APPROVED MINUTES

June 16, 2022 Standards Committee Meeting

RE: Minutes from the June 16, 2022 Standards Committee Meeting

E 801-TCTC-12 TUBULAR MARKER DELINEATION AT INTERSECTION (SHOWN MARKUPS)

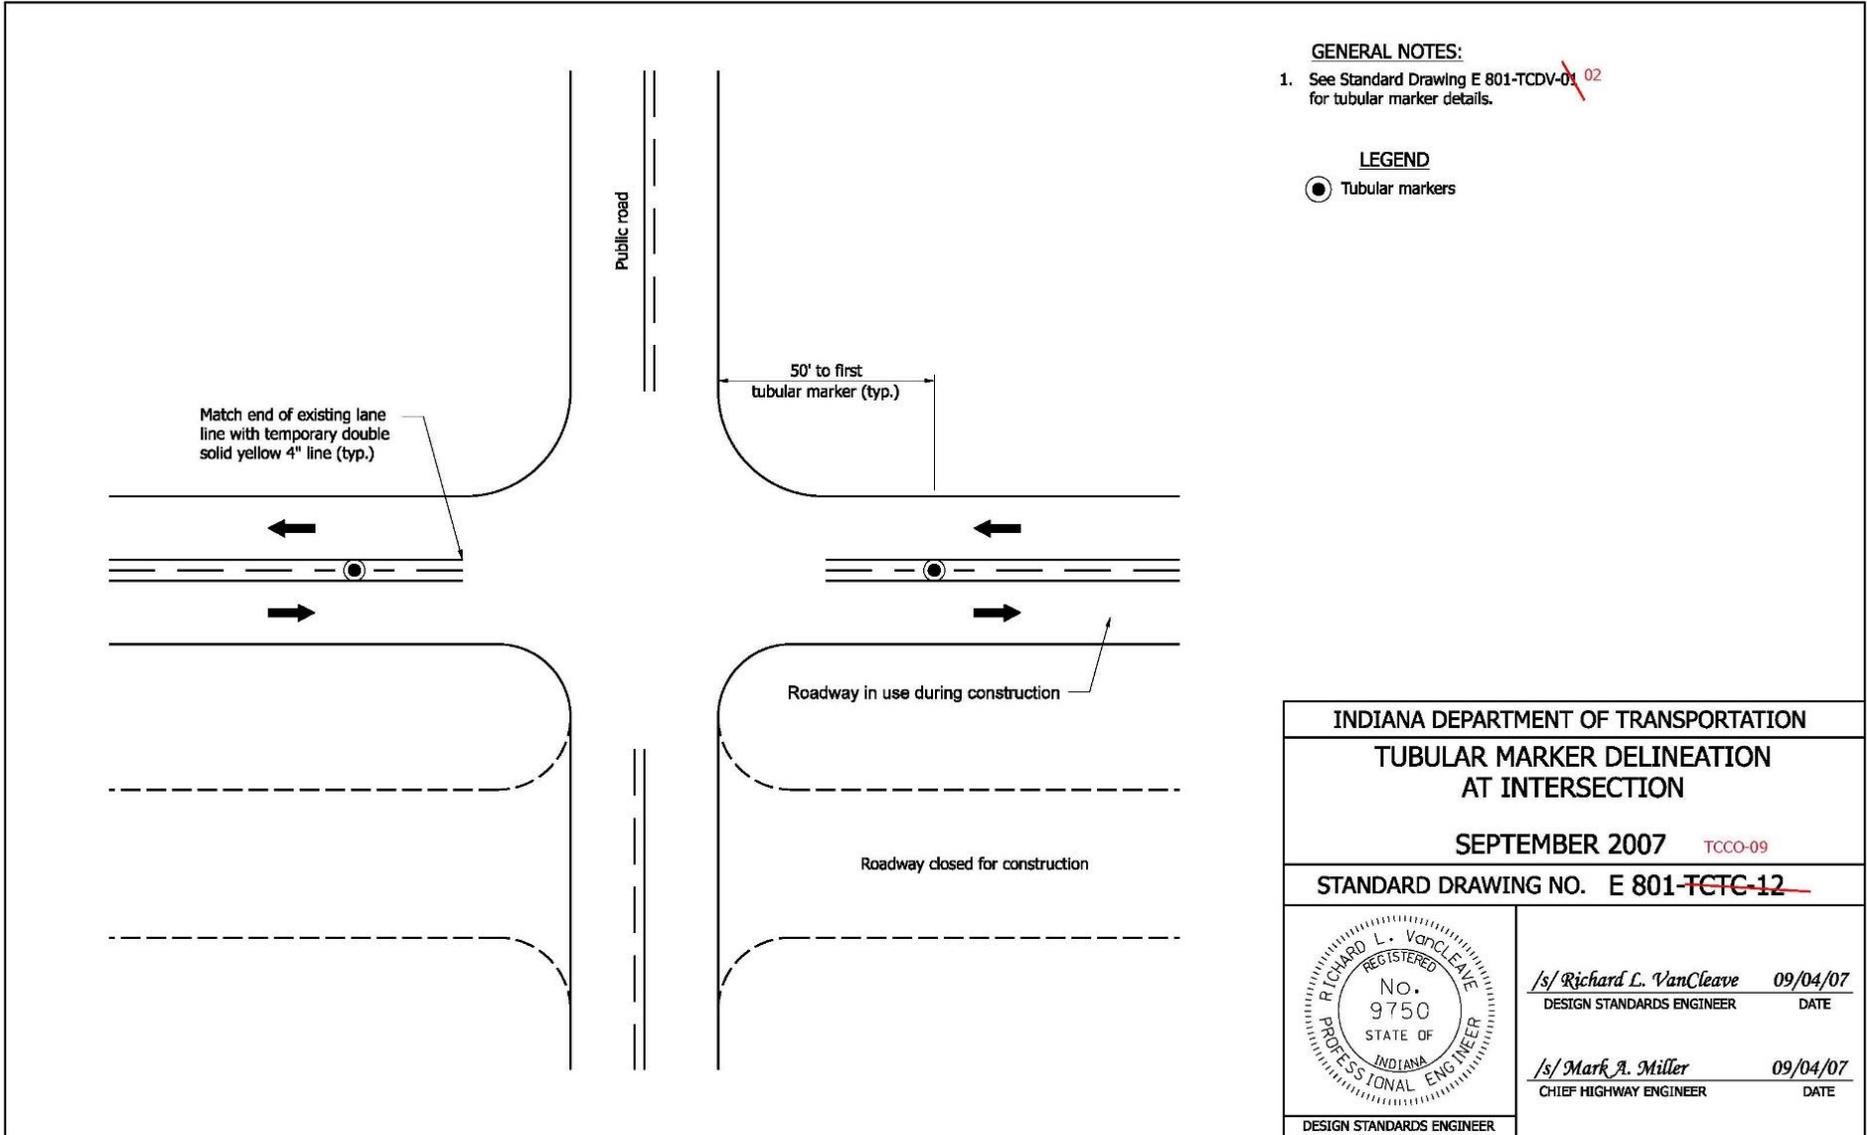
Move to 801-TCCO-09

E 801-TCCO-08 TUBULAR MARKER DELINEATION (PROPOSED DRAFT)

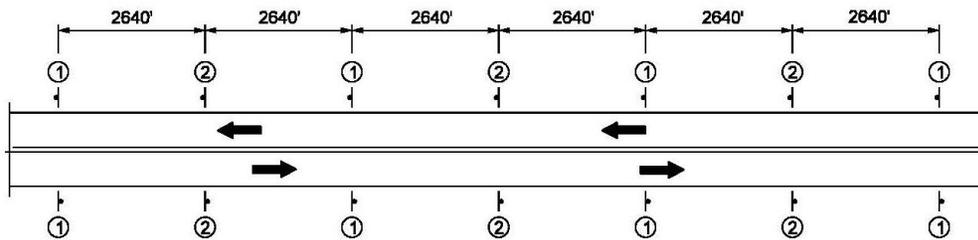
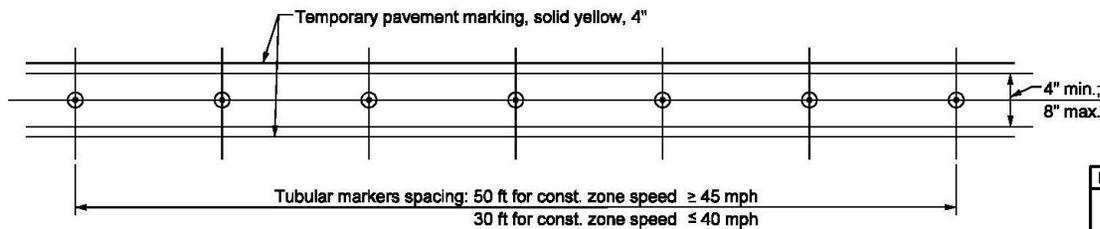
REVISIONS TO STANDARD DRAWINGS

E 801-TCCO-09 TUBULAR MARKER DELINEATION AT INTERSECTION (PROPOSED DRAFT)

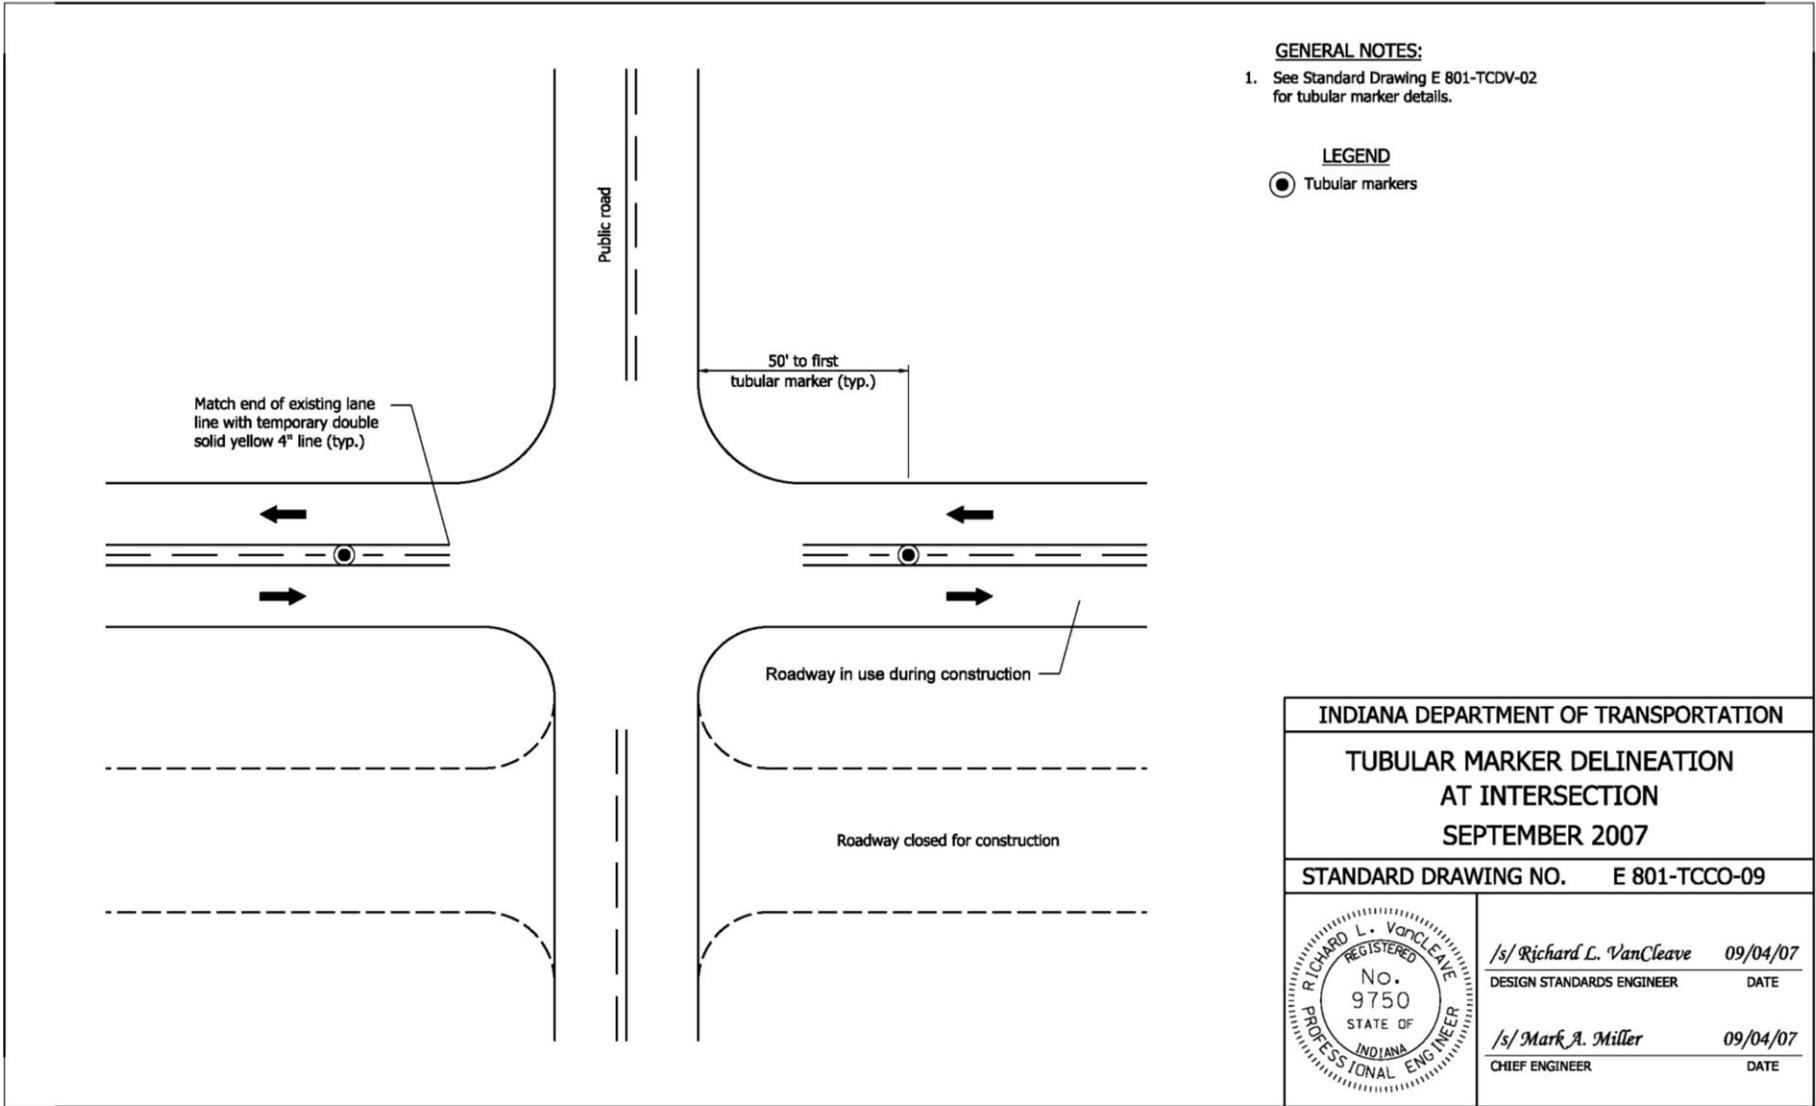
REVISIONS TO STANDARD DRAWINGS
